Access Compliance Report Public Rights-of-Way (Curb Ramps)

Main Street: ASCENSO_AVE		Cross Street: N/A		Location:	NE
ADA ID: RPRK211117154529	Ramp Type: Type 4 - Parallel	Initial Pass/Fail: Pass	Overall Compliance: No	Severity Score:	6
Codes/Mitigation Info/Possible Solution			Field Measurements/Component Compliance

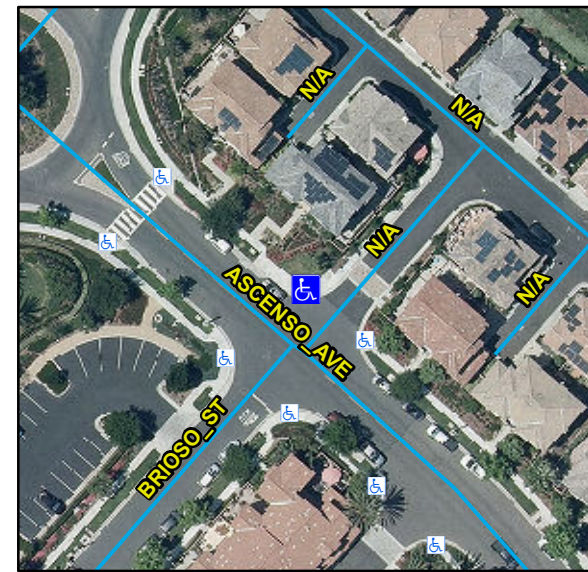
Compliance	Description	Data	Compliance	Description	Data
N/A	Ramp Length LT (in)	67	N/A	Ramp Length RT (in)	64
Yes	Ramp Width LT (in)	89	Yes	Ramp Width RT (in)	89
Yes	Ramp Run Slope LT (%)	6.5	Yes	Ramp Run Slope RT (%)	7.4
Yes	Ramp Cross Slope LT (%)	1.6	Yes	Ramp Cross Slope RT (%)	0.2
N/A	Landing Present	Yes	Yes	DWS Provided	Yes
N/A	Landing Length (in)	80	Yes	DWS Contrast	Yes
Yes	Landing Width (in)	48	Yes	DWS Length (in)	36
No	Landing Run Slope (%)	2.3	Yes	DWS Full Width	Yes
Yes	Landing Cross Slope (%)	1		DWS Offset Type	Single
N/A	Landing Movement Obstructed?	No	Yes	DWS Offset Left (in)	0
	Landing Movement Type	Curb	Yes	DWS Offset Right (in)	N/A
N/A	Landing Shared	No			
N/A	Clear Space	Yes			
N/A	Clear Space To Crosswalk (in)	48			
N/A	Marked Crosswalk 1	No	N/A	Marked Crosswalk 2	No
	Crossing 1 Direction	W		Crossing 2 Direction	S
	Marked Crosswalk 1 Width (in)	N/A		Marked Crosswalk 2 Width (in)	N/A
N/A	Ramp Inside Crosswalk 1	N/A	N/A	Ramp Inside Crosswalk 2	N/A

Crossing 1 Slope (%)	3.5		Crossing 2 Slope (%)	0.7
	Crossing 1 Cross Slope (%)	0.4		Crossing 2 Cross Slope (%)	0.5
Yes	Gutter Ponding	No	Yes	Curb Slope	6.9
Yes	Gutter Lip Height (in)	0		Road Run Slope (%)	1
No	Gutter Run Slope (%)	7.6		Road Cross Slope (%)	4.1
Yes	Gutter Cross Slope (%)	0.6	Yes	Perpendicular Joint Present	Yes
Yes	Overall Surface Condition	Acceptable			
	Cross Gutter Present?	No		Spandrel Present?	No
	Replace Cross Gutter?	N/A		Replace Spandrel?	N/A

Remove & Replace Landing. Remove & Replace Gutter.
